**CITY OF BEVERLY HILLS
PUBLIC WORKS DEPARTMENT
345 FOOTHILL ROAD
BEVERLY HILLS, CALIFORNIA 90210**

ADDENDUM NO. 1

**Request for Proposal to Provide
Professional Lighting Services for the Procurement, Installation, Maintenance, Removal and
Replacement of Warm White LED Lights on Trees
within the City of Beverly Hills**

**Project No. 18-28
May 11, 2018**

EXHIBIT A: MAP OF THE CITY EXISTING LED TREE LIGHTING PROGRAM

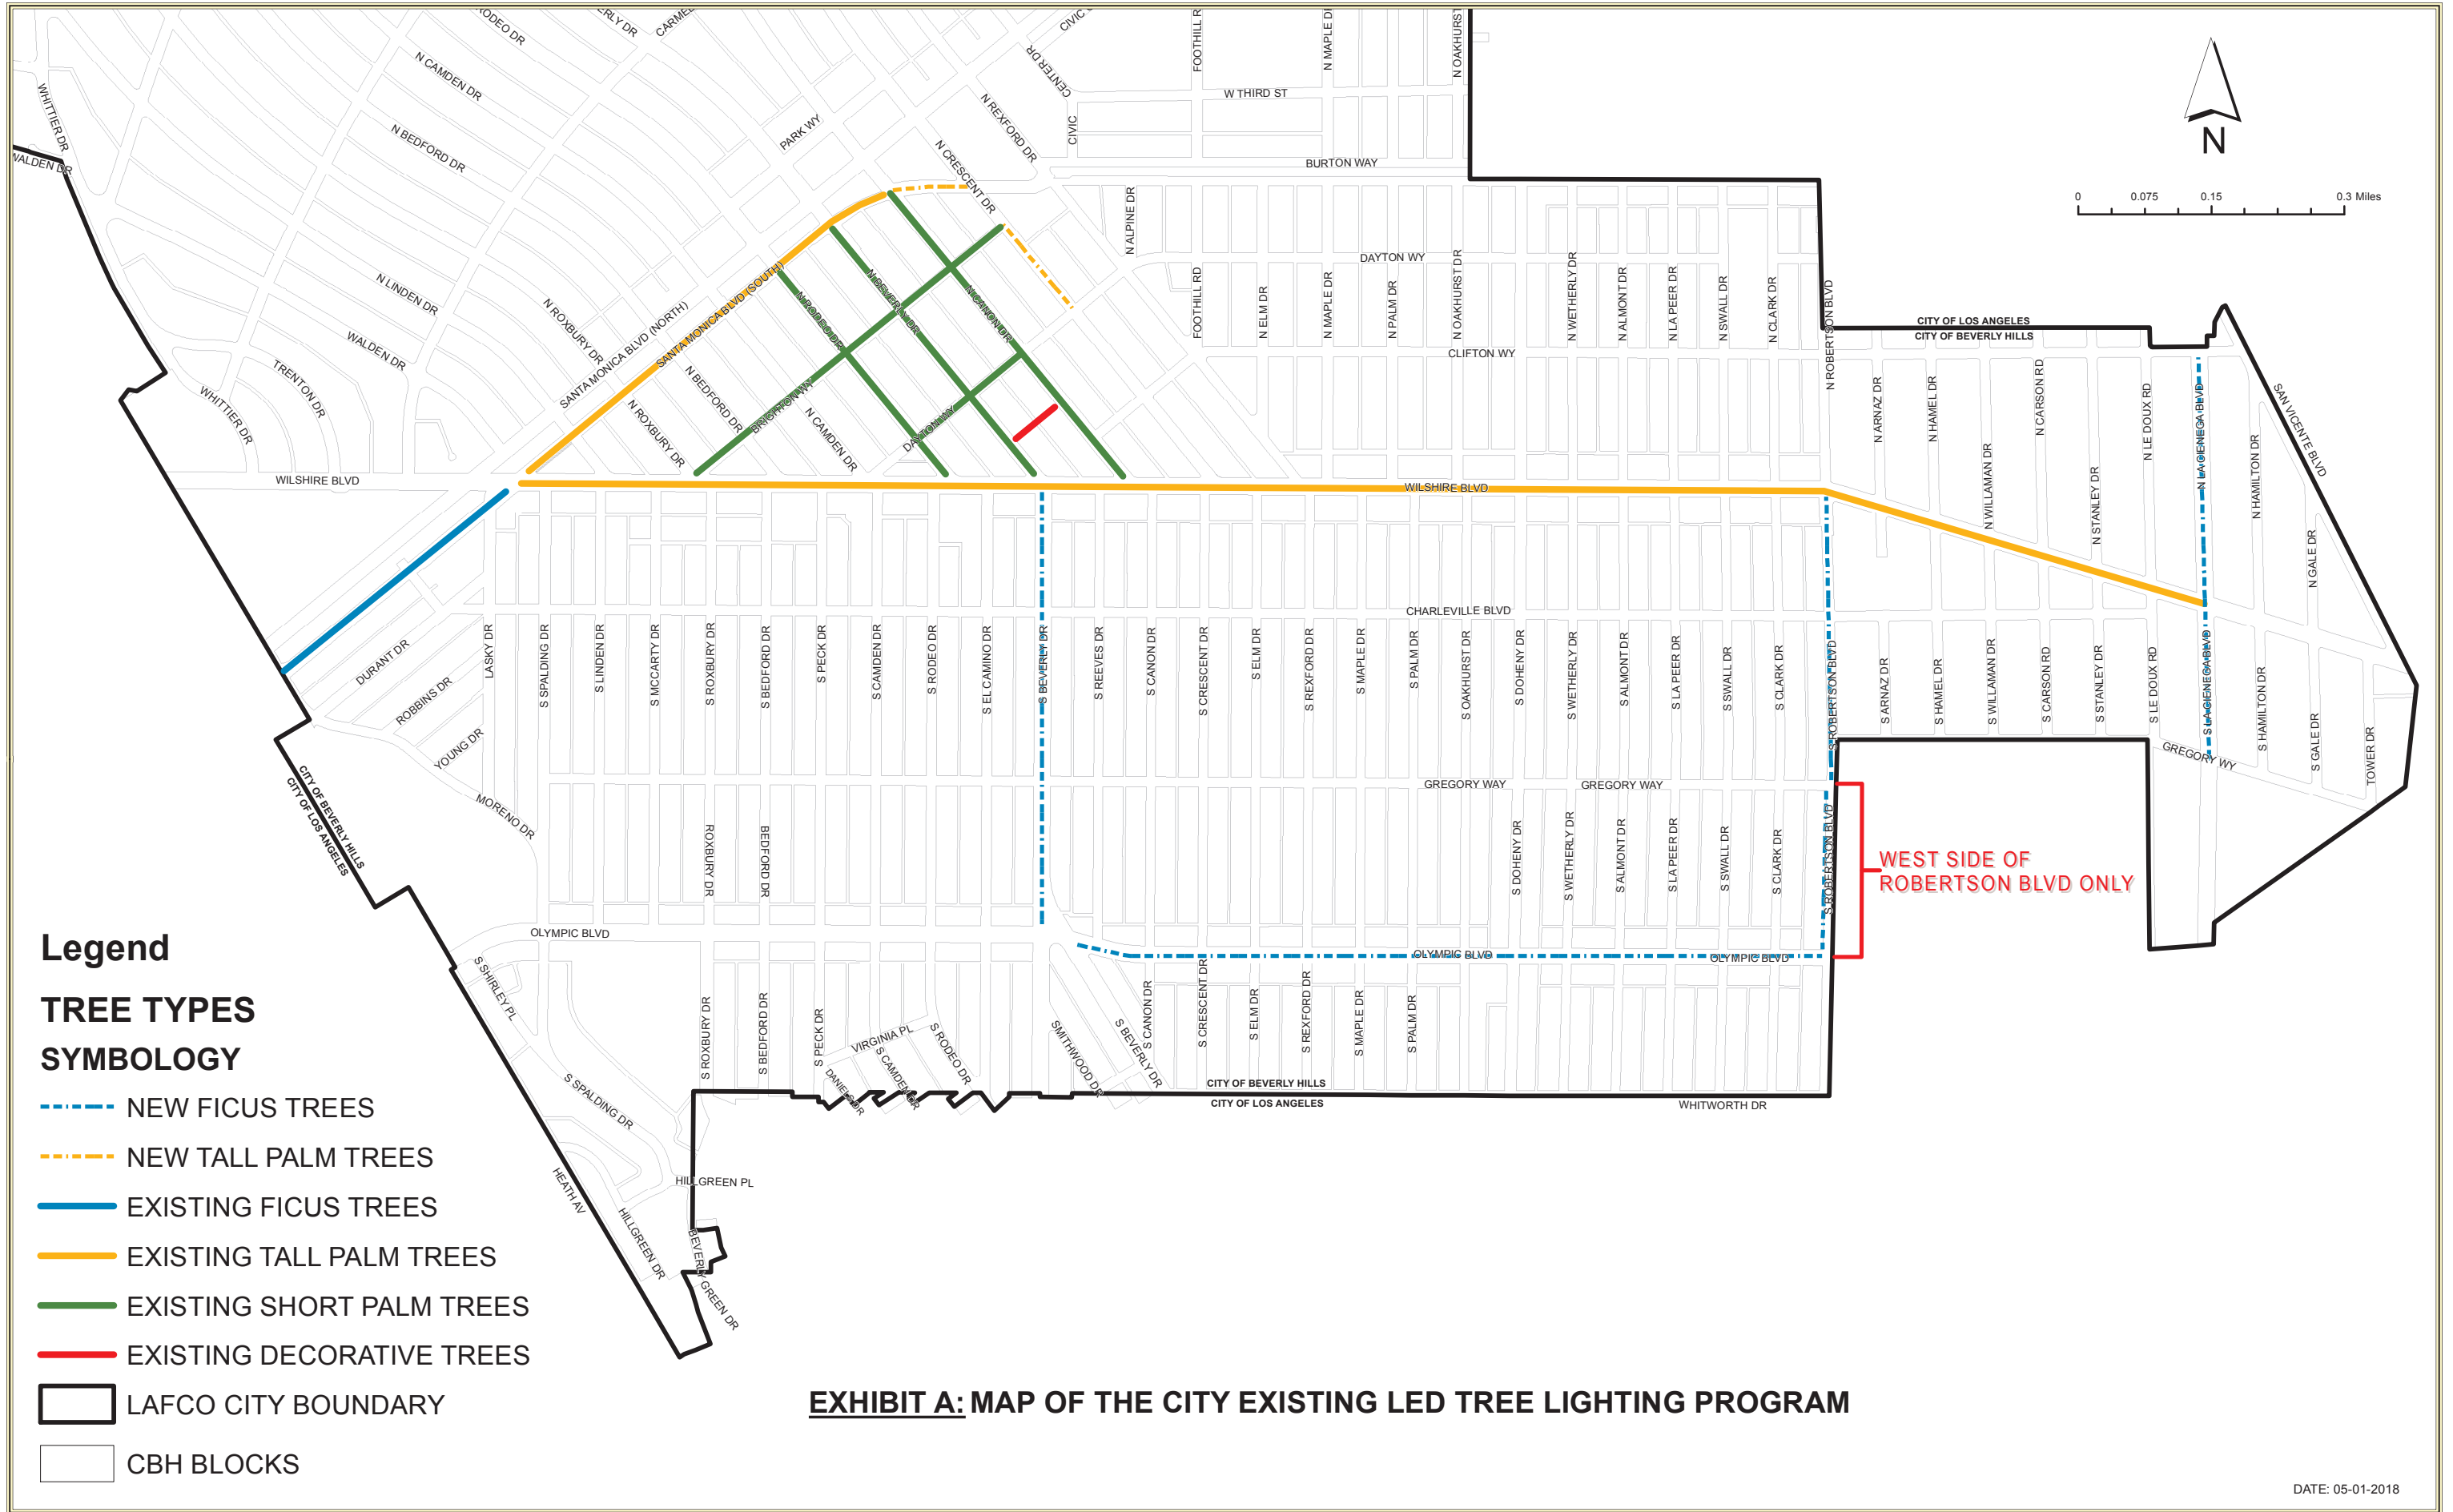
Item No. 2 – Vendors shall use the attached Revised Exhibit A dated (05-01-2018) to replace original Exhibit A provide in RFP.
